**POWERLINK RESPONSE TO AER DRAFT DECISION of 8 DECEMBER 2006**

# POWERLINK QUEENSLAND

QUEENSLAND TRANSMISSION NETWORK  
RESPONSE TO AER DRAFT DECISION  
of 8 December 2006

**Figure 3.2: Condition Based Maintenance Trend (indicative)**

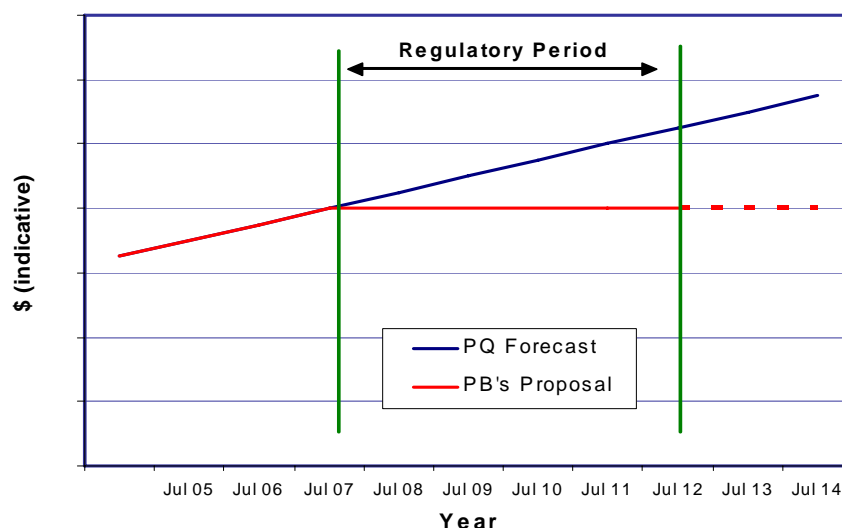
Powerlink believes that PB's recommendation of not increasing condition based maintenance with network growth for the period of the coming five year regulatory period is not acceptable. Given the reality of early life failures and the potential consequences (e.g. threats to public safety), an approach of no increase in condition based maintenance on a continually growing network is clearly unsustainable. PB has not identified an alternative time at which condition based maintenance would be increased to reflect the increased network size – would that be at the beginning of the following regulatory period? If not then, when? Powerlink has difficulty in believing there is any linkage between condition based maintenance requirements and the timing of Powerlink's regulatory periods.

**Figure 2. Early Life Failure Pattern**

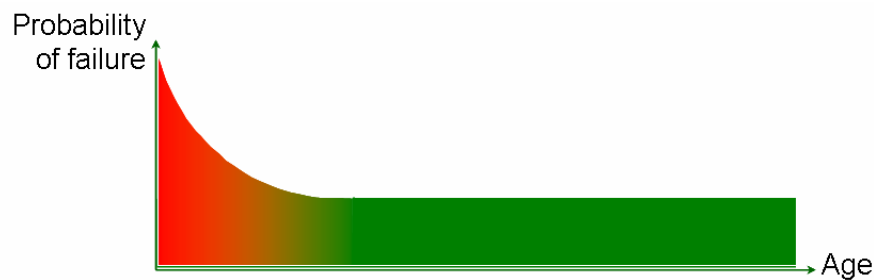
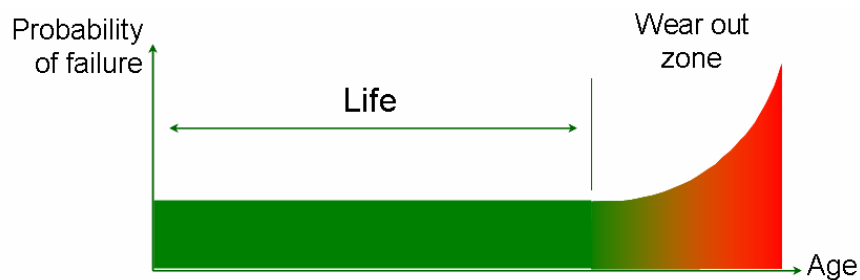
It appears that PB Associates have only considered this last scenario and in doing so, have dismissed Powerlink's proposition that Condition Based Maintenance costs will increase as a result of an increase in the number of assets.

**Figure 4. P-F Curve**

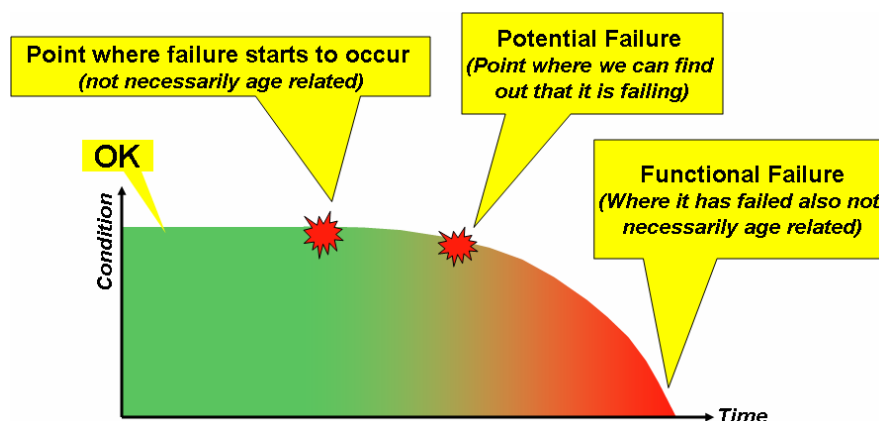
As illustrated in Figure 4 below, Condition Based Maintenance assesses the condition and performance of an asset allowing action to be taken before the full functional failure occurs. It is this very behaviour of monitoring the performance of assets at a frequency based on the PF interval, which has contributed to Powerlink being an industry leader in asset performance, reliability and cost.

**Figure I1: Tarong grid section power transfer for scenario 9, medium economic growth**

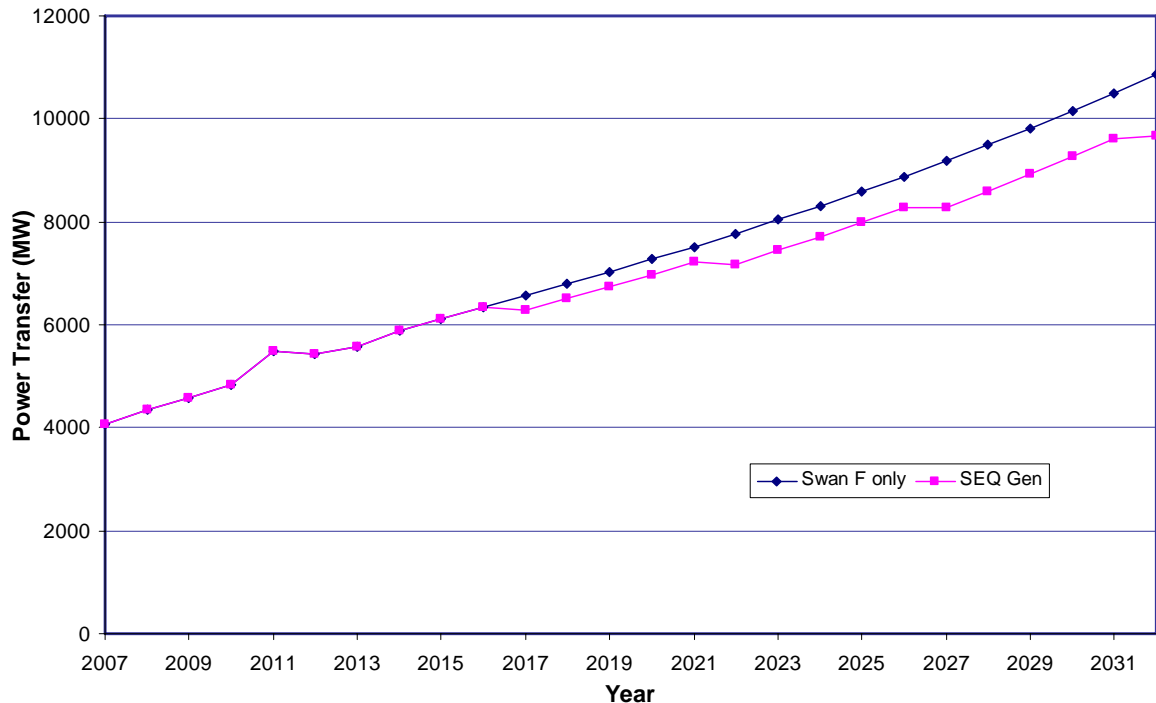
In determining that 500 kV should be constructed on these easements, the indicative future power transfer across the Tarong grid section such that reliability of supply to SEQ is maintained is shown in Figure I1. These transfers are based on medium economic growth and assumes Swanbank B retires in 2011 followed by the planting of
